E	mail: info@edac.net ENGINEERING CHANG	http://www.edac.net	
			Date:	Document Number	
Originator: Harsh Patel		January 20, 202	FCN20240420.00		
Phone No. (416) 754-3322			January 29, 202	ECN20210129-00	
Email Address:	<u>Hp</u>	atel@edac.net	Revision Number	er SHEET	
Department _	ENGINEERING		1	1 of 2	
_					
CHANGE TYPE					
CLASS I Customer notification and approval required prior to implementation					
X CLASS II	X CLASS II Customer notification only, no approval required				
CLASS III	No customer notific	ation required			
REASON OF CHANGE					
Improvement done to preve	nt high voltage defect ir	HDMI A, 19 PIN, R/A, SOL	DER MOUNT, P/N-690-019-598	T312.	
DESCRIPTION OF CHANGE:					
Pin locating slot removed	to prevent high voltage	defect in HDMI connector.			
Old Drawing No New Drawing No 690-019-598T312, Rev-02 690-019-598T312, Rev-03					
690-019-598T312, Rev-02			090-019-3901312,	090-019-3901312, Nev-03

13A-F002 Engineering Change Request (Supplier)

HDMI A, 19 PIN, R/A, SOLDER MOUNT

690-019-598T312

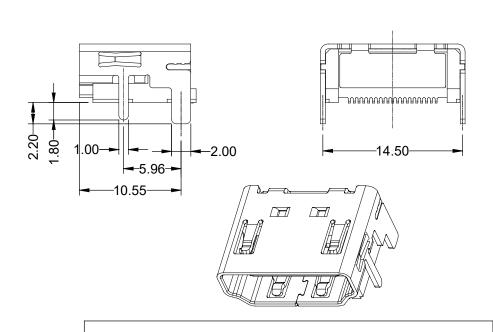
2. Operating Temperature ra 3. TIN Plating on Solder are 4. Effective implementation Note:- It's a drop in replacer	a increased from 100μ' to distribution is on Jan	min to 100 ~ 120µ" min.	e.There is no any change in form	1.30	
PARTIES AFFECTED		□ NODGOM	D		
X Customer X Distributor Suppliers		MH X ETW		X ECA X EDG X EDAC UK	
KEY TARGET DUE DATES IF CHANGE IS APPROVED TO PROCEED (check if applicable and show target dates as known)					
Submit Quote					
Prod. Trial Ru Run at Rate			MRD of Production Pa	ırts	
ACI	KNOWLEDGEMENT F	OR ECN INITIATION: (OPTI		STATUS APPROVED	
Mfg Eng Rep Production Rep		Facilities Rep.		CCS CHANGE REQUEST #	
Materials Rep		Product Eng. I		OGG OFFINGE REQUEST #	
Quality Rep Purchasing Rep					
	APPROVALS FOR E	CN INITIATION (REQUIRE	D)	REJECTED Change REJECTED by:	
Presid	dent	Enginee Mana			
□ □ Vice Presid	dent Bob Sakitkovski	Mechar Engli		Rejected Date:	
MINIMUM OF	TWO SIGNATURES REQUIR

REMOVE LOCATING SLOT UPDATE OPERATING TEMP. UPDATE TIN PLATING THICK. JAN. 29/2021 (3)

OPERATING TEMPERATURE: -40°C ~ 85°C

100 ~ 120μ" min. TIN PLATING ON SOLDER AREA,
